Wisconsin Department of Transportation

Proposal #07: 5130-05-63, WISC 2023238
Ontario - Tomah
STH 71 - CTH A/B-41-21,-136,-137
STH 131
Monroe County

This is Addendum No. 01, which provides for the following:

ADDENDUM NO. 01

Addendum No. 01
 ID 5130-05-63
 Revised Sheet 33
 January 23, 2023

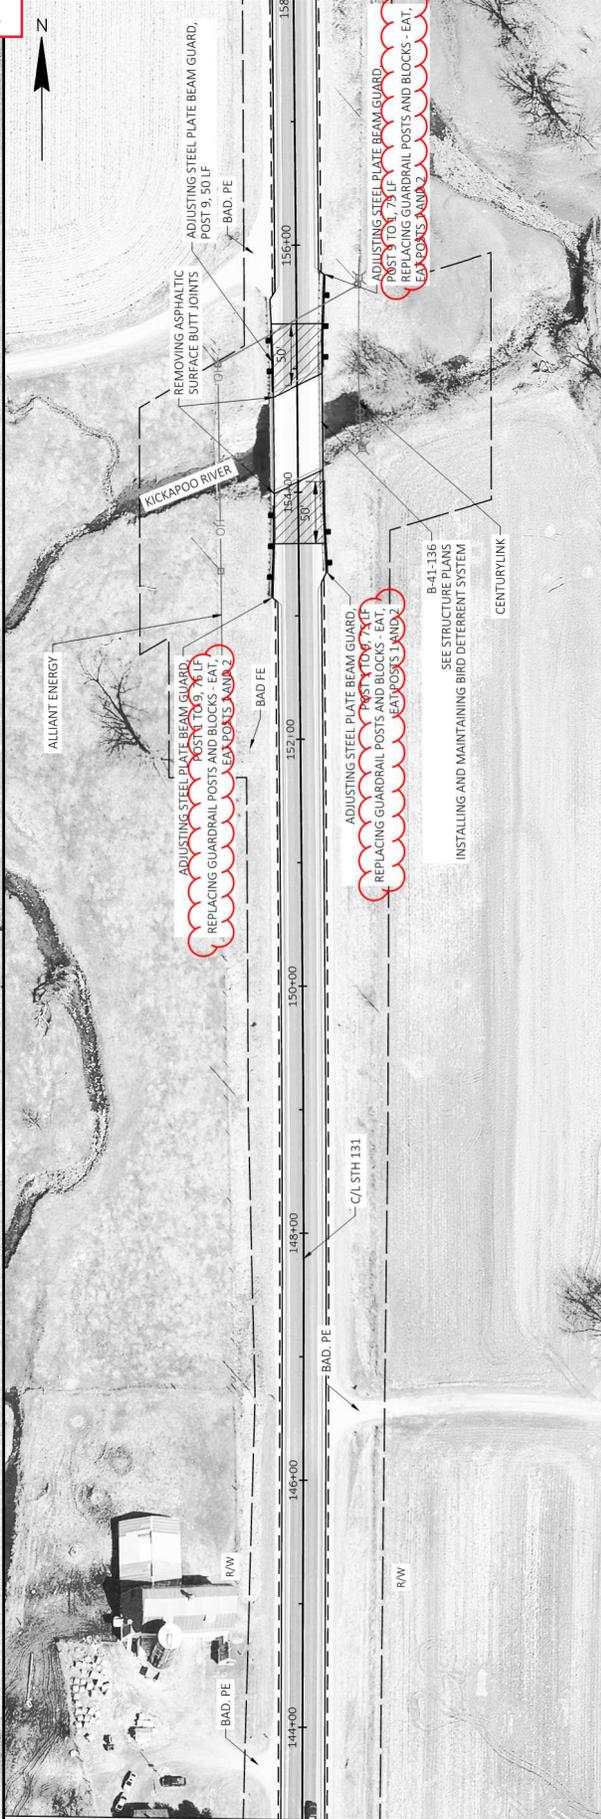
ADJUSTING STEEL PLATE BEAM GUARD
 POST TO 6' 7 1/2 LF
 REPLACING GUARDRAIL POSTS AND BLOCKS - EAT,
 EAT VOS'S 1 AND 2

ADJUSTING STEEL PLATE BEAM GUARD
 POST TO 9' 50 LF
 REPLACING GUARDRAIL POSTS AND BLOCKS - EAT,
 EAT VOS'S 1 AND 2

Addendum No. 01
 ID 5130-05-63
 Revised Sheet 34
 January 23, 2023

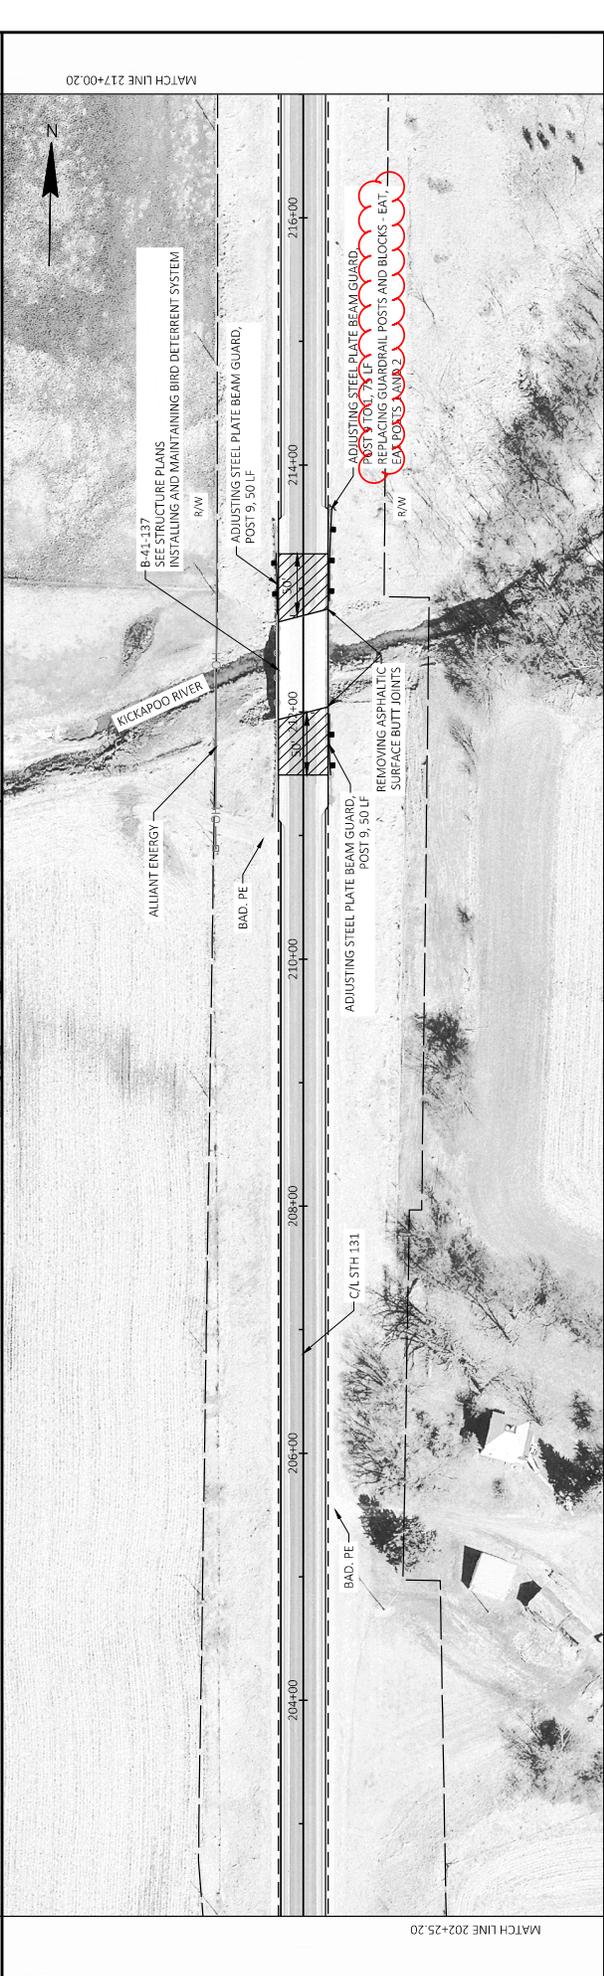
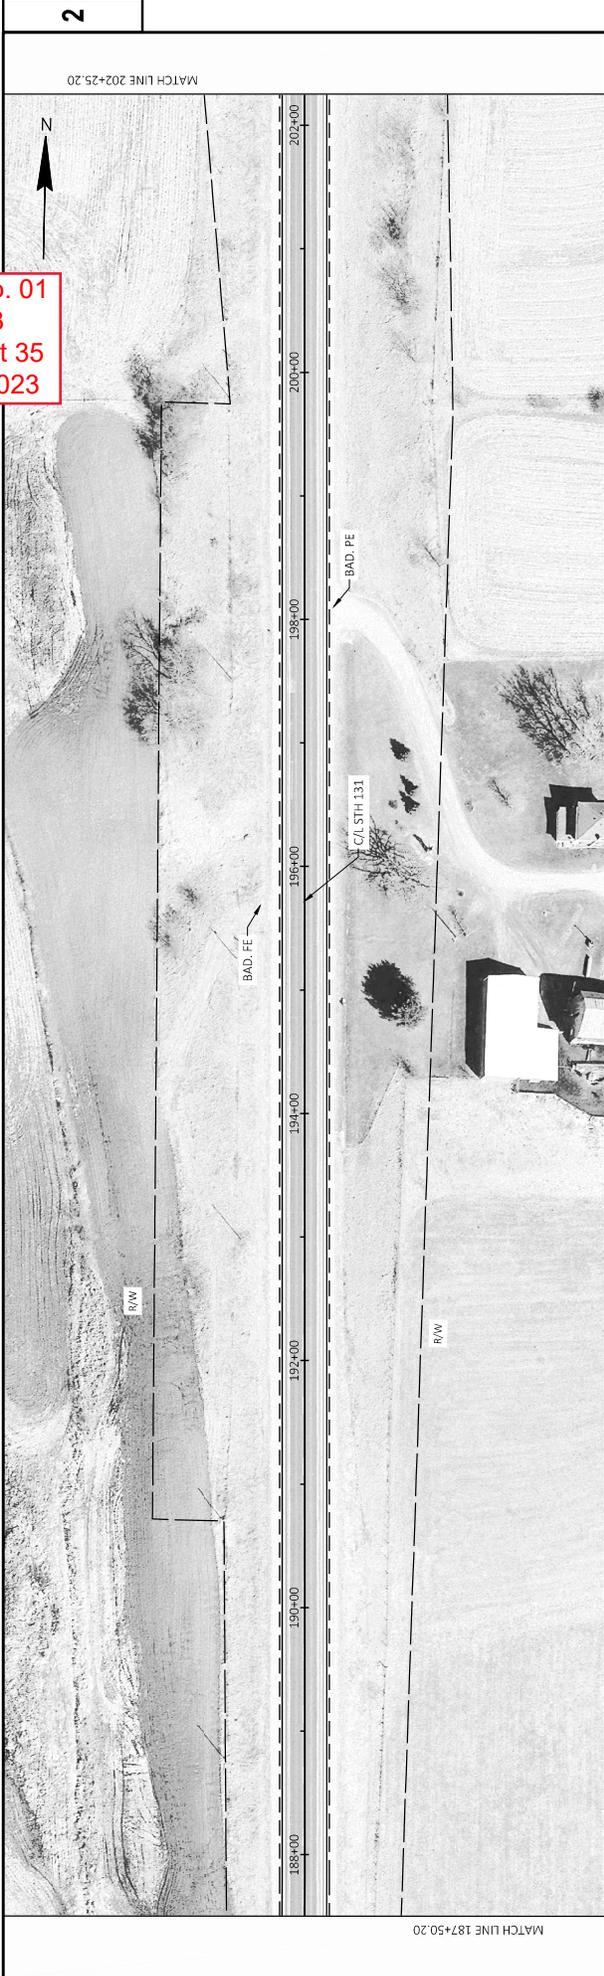
Revised Plan Sheets	
Plan Sheet	Plan Sheet Title (brief description of changes to sheet)
28	Miscellaneous Quantities (revised and added item quantities to Beam Guard Summary)
32	Plan (revised item name in callouts)
33	Plan (revised item name in callouts)
34	Plan (revised item name in callouts)
35	Plan (revised item name in callouts)
36	Plan (revised item name in callouts)
38	Plan (revised item name in callouts)
39	Plan (revised item name in callouts)

Addendum No. 01
 ID 5130-05-63
 Revised Sheet 38
 January 23, 2023

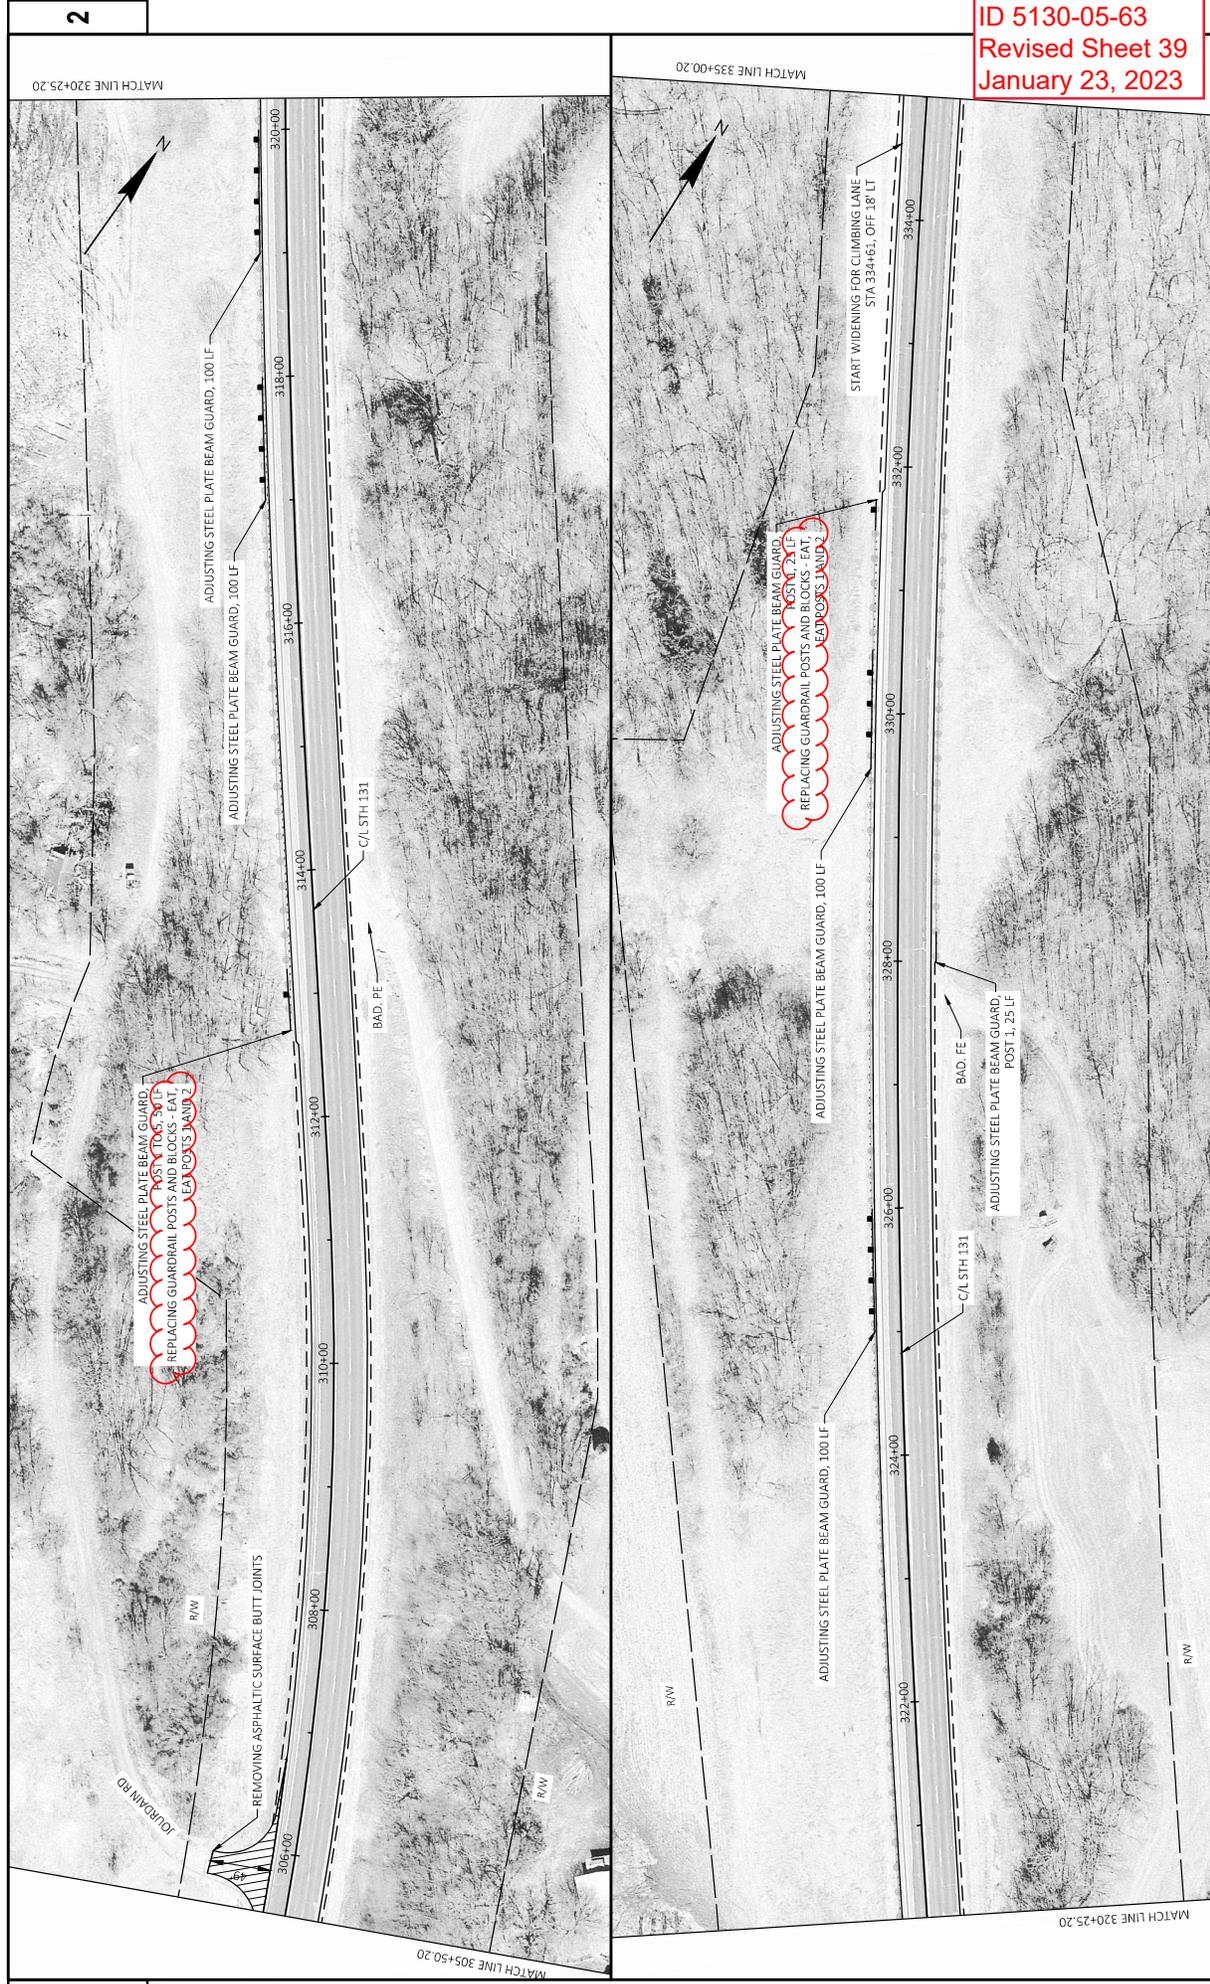
ADJUSTING STEEL PLATE BEAM GUARD,
 REPLACING GUARDRAIL POSTS AND BLOCKS - EAT,
 EX POSTS AND ?

ADJUSTING STEEL PLATE BEAM GUARD, 475 LF
 REPLACING GUARDRAIL POSTS AND BLOCKS, 32 EACH
 REPLACING GUARDRAIL POSTS AND BLOCKS - EAT,
 EX POSTS AND ?

ADJUSTING STEEL PLATE BEAM GUARD,
 REPLACING GUARDRAIL POSTS AND BLOCKS - EAT,
 EX POSTS AND ?
